project no: **12/03** project title: **Impact 2**
 Edward Street SHEFFIELD
 drawing no: **005** drawing title: **LEVEL 2 PLAN**
 revision: **J** date: **Aug 2013** drawn by: **J** approved by: **J**
 scale: **1:100 @ A1**
 drawing status: **FOR CONSTRUCTION**

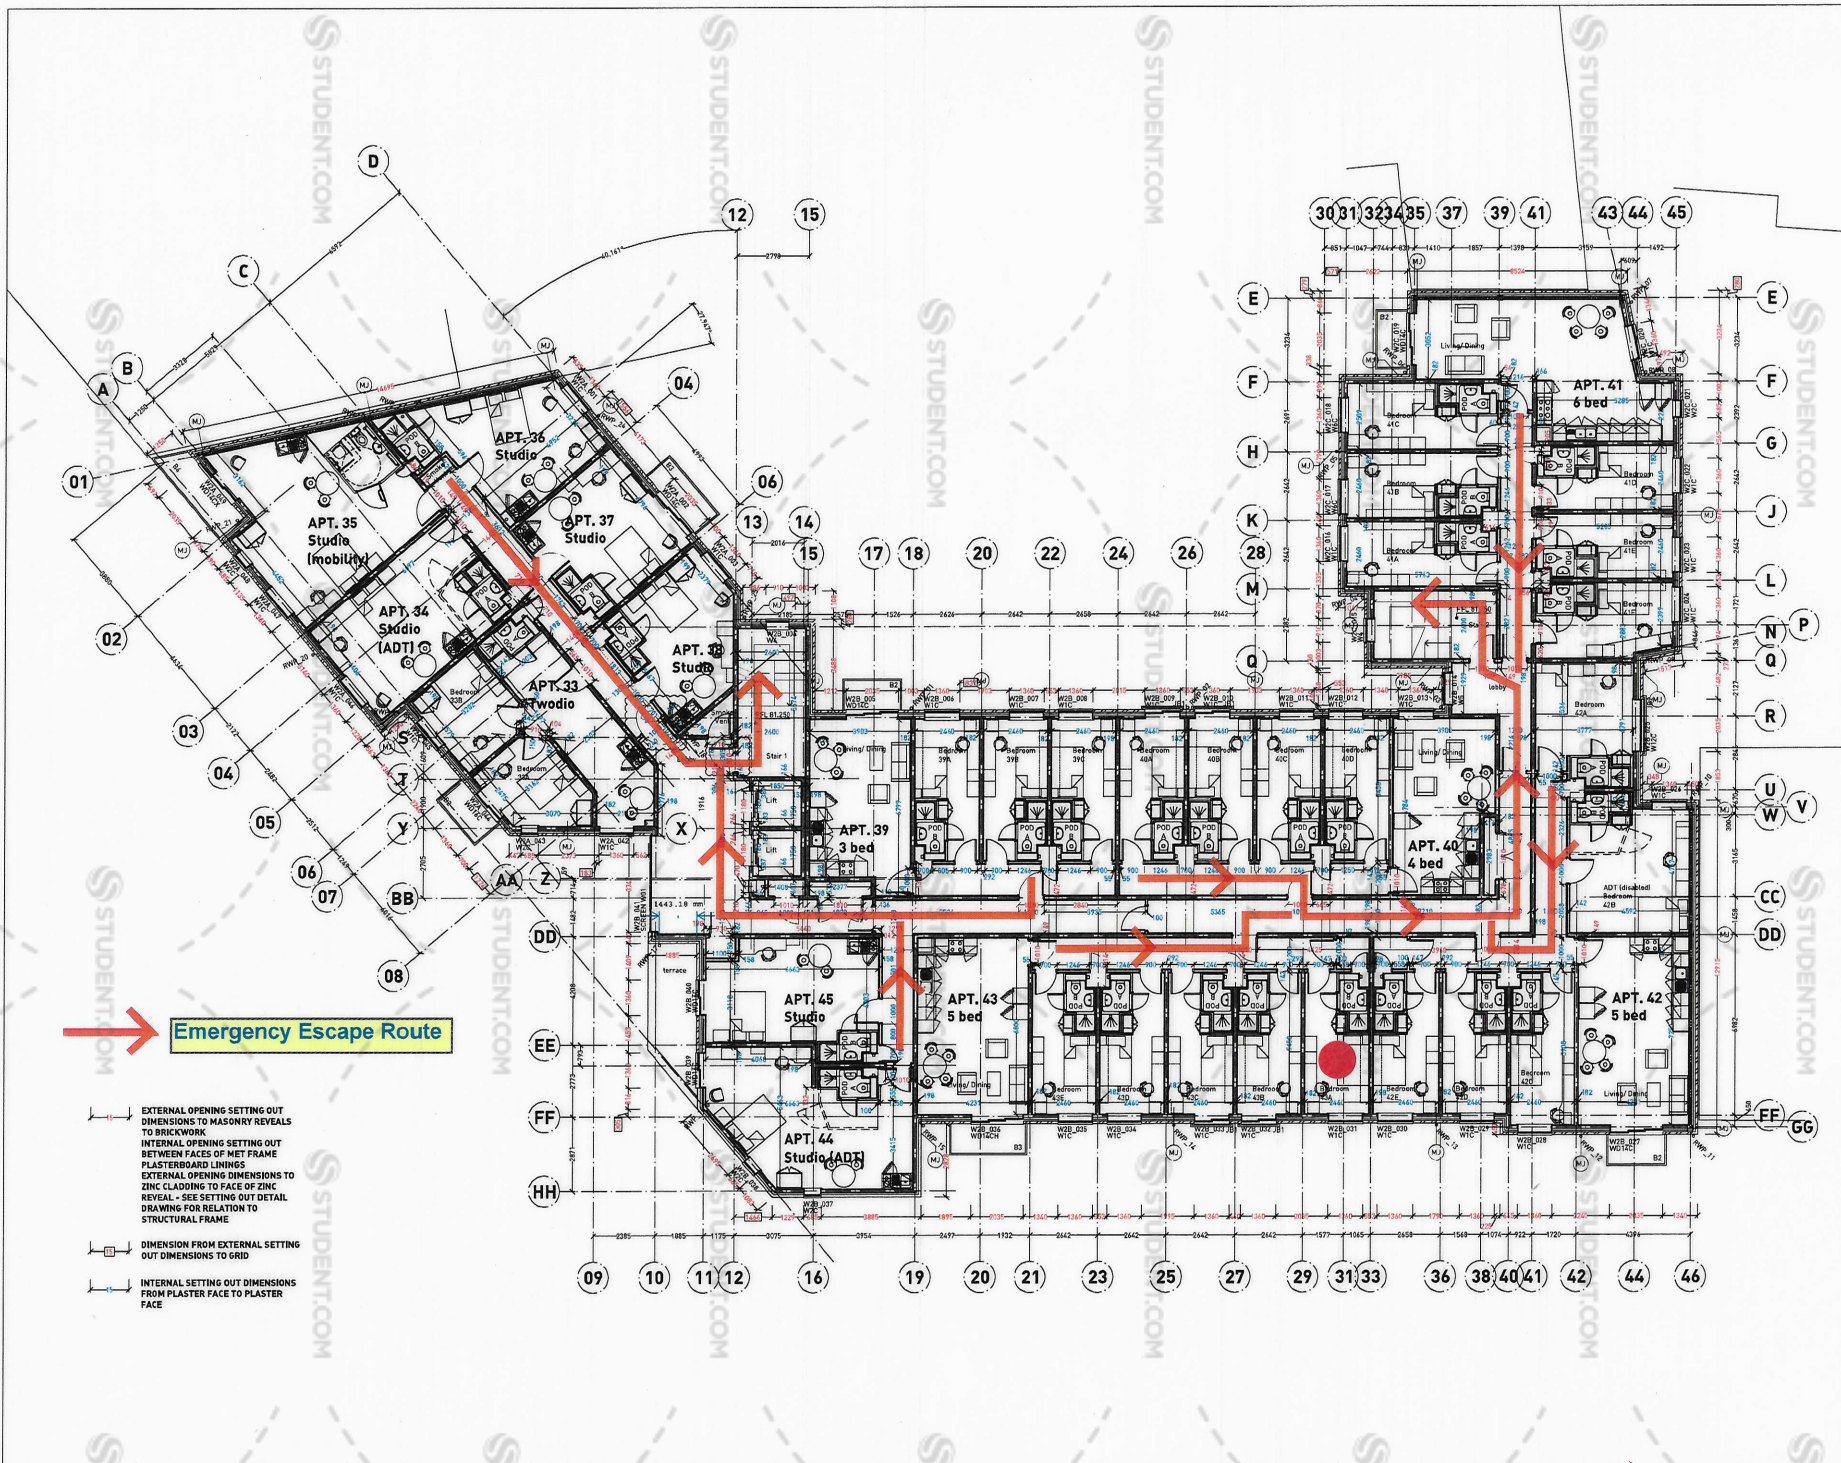
- Revision - Date**
- Rev A - 15/08/13
 Layout completely revised to Met Frame construction, Edward Street frontage moved back 600mm/corridor, lift/stair 1 room moved back 300mm.

- Rev B - 17/09/13
 General revision to layout and grid lines
 - Rev C - 26/09/13
 Internal Structural Opening Setting Out dimensions added, key to dimensions added, Wall - Out 1-44 increase to structural 198, Wall - D10-44 corrected to 182, Out 17 corrected 100mm towards grid 18. Note regarding resilient bar to 182 walls added

- Rev D - 02/10/13
 Issued for construction. Staircase 1 rear wall and associated gridline P moved by 502mm to enable staircase walls to align as requested by PAW. External floor level indicated in coordination with M&E consultants requirements. Grids 17 & 24 is structural Met Frame. Also wall between Apt 44 and Apt 45 corridor revised to be structural Met Frame. All as requested by PAW. Dry riser added to Stair 2

- Rev E - 08/10/13
 Fire curtain added, lift openings added, room numbers amended to have inter reference, mobility and ADT (disabled) rooms amended as instructed. Finish floor levels added, movement joints and rainwater points added

- Rev F - 08/11/13
 New rear roof rise done revised to 700mm & external fire enclosure removed as instructed by contractor, position of full landing window on stair 1 is revised, window, dry riser corridor fire indicated, balcony references & communal cupboard to lift lobby added

- Rev G - 20/01/14
 Glass corridor door to block A, anti-theft lock 1 cross corridor wall revised to 100mm thick, all as required by fire consultant. Window referencing added

- Rev H - 03/03/14
 Smoke vent added to Block A as required by B Control Apt 38 pod access door relocated, Apt 35 disabled bathroom repositioned with kitchen & studio layouts indicated, window W2A_047 & adjacent brick pier revised to LPA requirements, window W2A_047 corrected additional plaster face dims added to N&B partitions Rev 1 - 23/04/14
 Window W2A_049 to Apt 35 A adjacent brick pier revised to LPA Rev 1 - 18/05/14
 Door savings revised to stair 1 and block A corridor to enable mechanical venting to block A smoke shaft
